From: <David.Stein@CH2M.com>
To: <Bpfanner@energy.state.ca.us>
Date: 9/27/2007 10:13 AM
Subject: Eastshore Minor Pole Location Update - Possible Elimination of a Single Transmission Pole (#16)
Attachments: minor pole location update.pdf

MINOR POLE LOCATION UPDATE - Potential Elimination of Pole #16

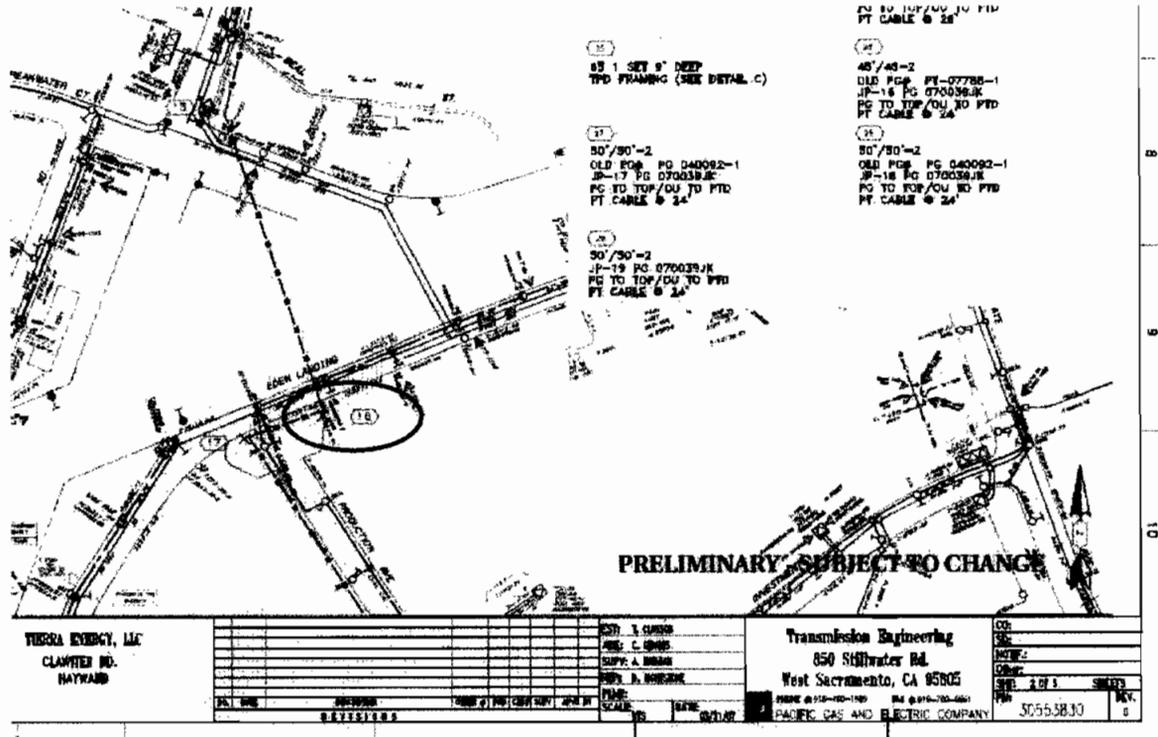
It has come to my attention that PG&E is actually considering a 2nd (and preferred) option for the overcrossing of SR-92 that differs only very slightly from what we submitted in our PSA Comments Attachment BIO-1 in that their preferred option would eliminate one pole (#16). I wanted to informally advise you of this very minor POSSIBLE change that I do not believe materially impacts anything we have submitted to address biology staff concerns.

I'm attaching an excerpt from our recent PSA comments (the 2nd page of Attachment BIO-1) that clearly shows what we are talking about. Nothing is final yet as Caltrans has not agreed to the elimination of pole #16. The material that was included in our Attachment BIO-1 of our recent comments is definitely the worst-case and until Caltrans makes a final determination, both options are in play.

Pole #16 may be eliminated depending on PG&E negotiations with Caltrans. The elimination of this pole would be PG&E's preference as it would lower installation cost (one less pole to install and a slightly shorter length of transmission line to complete the SR-92 overcrossing)
